Design change: Sealing and flange housing – M12 circular connector

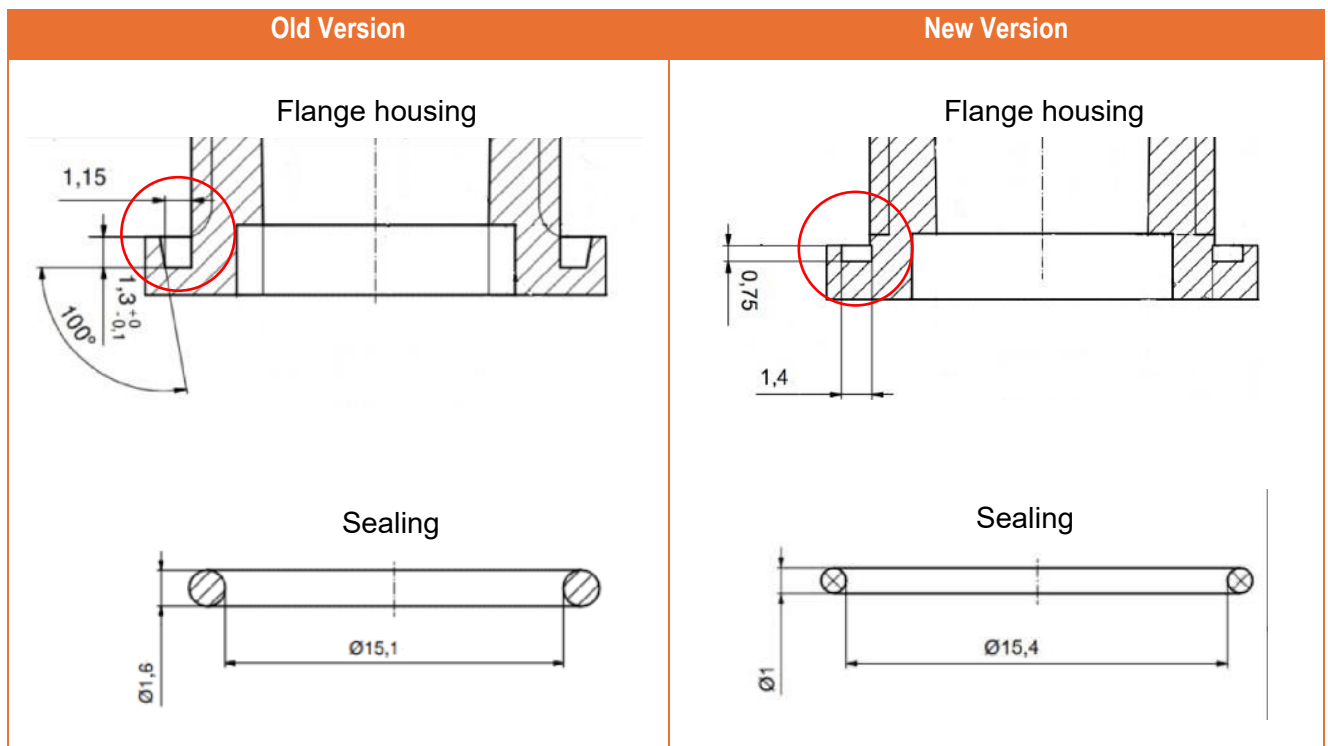
To improve long-term stability under demanding environmental conditions, the sealing ring (O-ring) and the associated sealing groove have been redesigned.

The IP protection rating specified in the datasheet remains valid as long as the specified front panel cutout is maintained. There is no cross-compatibility between the old and new versions: Old flange housing only with old sealing, new flange housing only with new sealing.
